Piper Aircraft Corporation
Lock Haven, Pennsylvania, U.S.A.

SERVICE No. 222A BULLETIN

SUBJECT: Removal of Restriction to Air Speed Limits
(Replacement of Stabilator Torque Tube)

MODELS AFFECTED: PA-30 Twin Comanches, Serials 30-1 to 30-482 incl., 30-484 to 30-491 incl., 30-493, 30-494, 30-496 to 30-502 incl., 30-504, 30-505, 30-507 to 30-565 incl.

STAGE FOR EXPORT FIRE RELEASE	
SKETCH A	REV. 75-52
PIPER AIRCRAFT CORPORATION	
LOCK HAVEN, PENNSYLVANIA

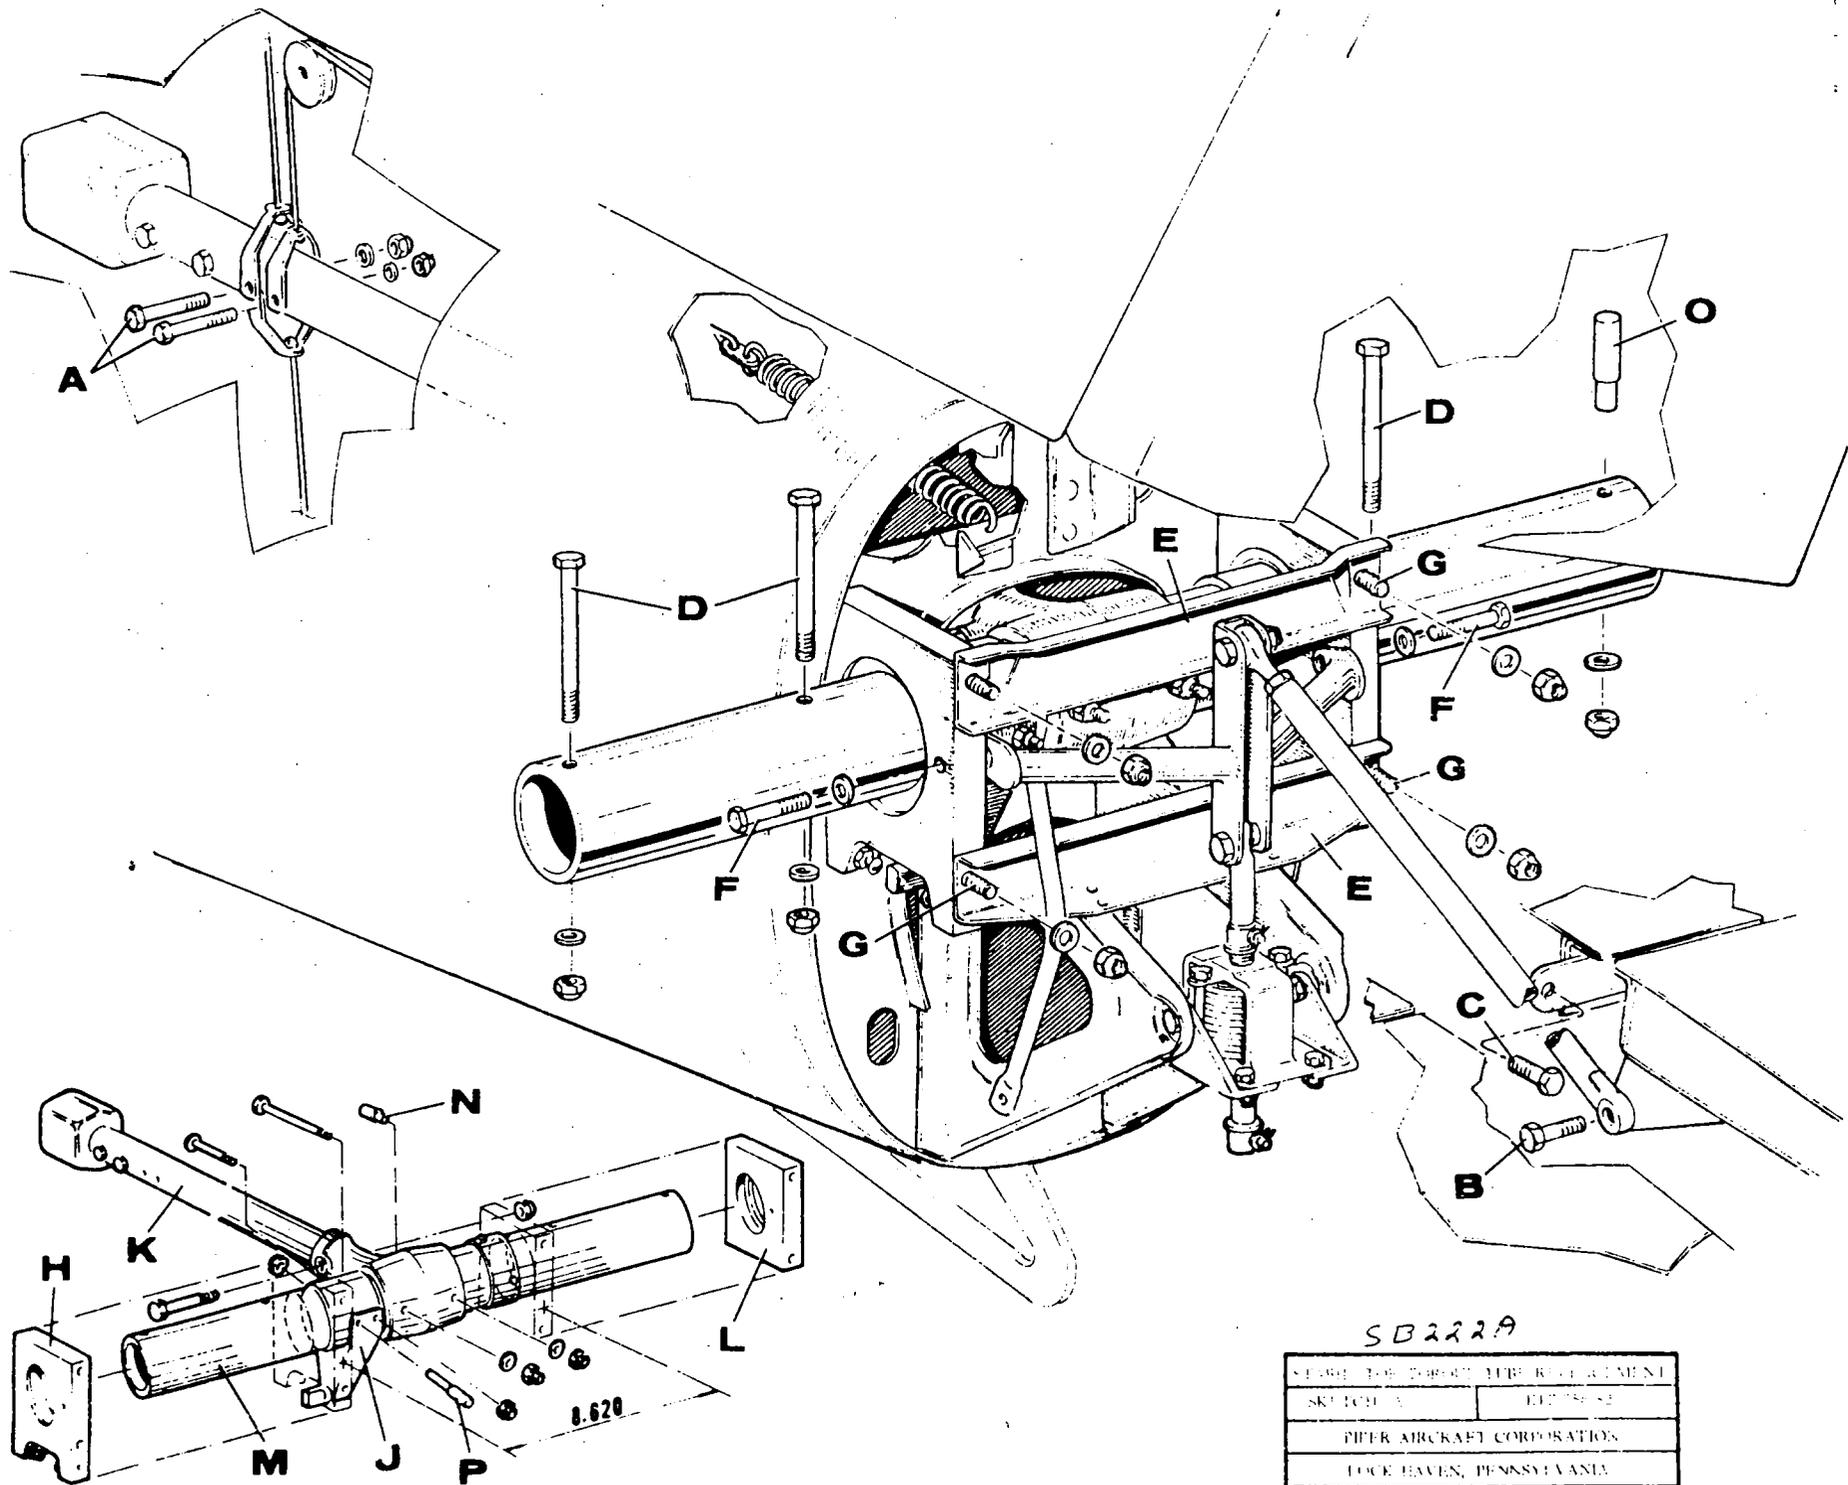
It has been determined that a stabilator torque tube, part number 22655-07, of heavier wall thickness will eliminate this vibration.

16. Install counterbalance arm assembly on new stabilator torque tube, part number 22655-07. Note position in View B. Item M.

Holes drilled in the torque tube assembly are undersize and will be line-reamed on assembly. Since the holes in counterbalance arm assembly and stabilator fittings have already been

reamed, a special locating pin, part number 25034-00 is included with each torque tube to insure proper fit of these assemblies. Item N.

Ream the other hole in the tube to .3120 to .3130. Insert bolt in reamed hole before removing locating pin to ream the second hole.

Ream the other hole in the tube to .2465 to .2475. Insert bolt in reamed hole before removing locating pin to ream the second hole.

Shims, part no. 81262-72, should be installed with bearing blocks in same position as when removed to maintain a dimension of 8.620 shown in View C.
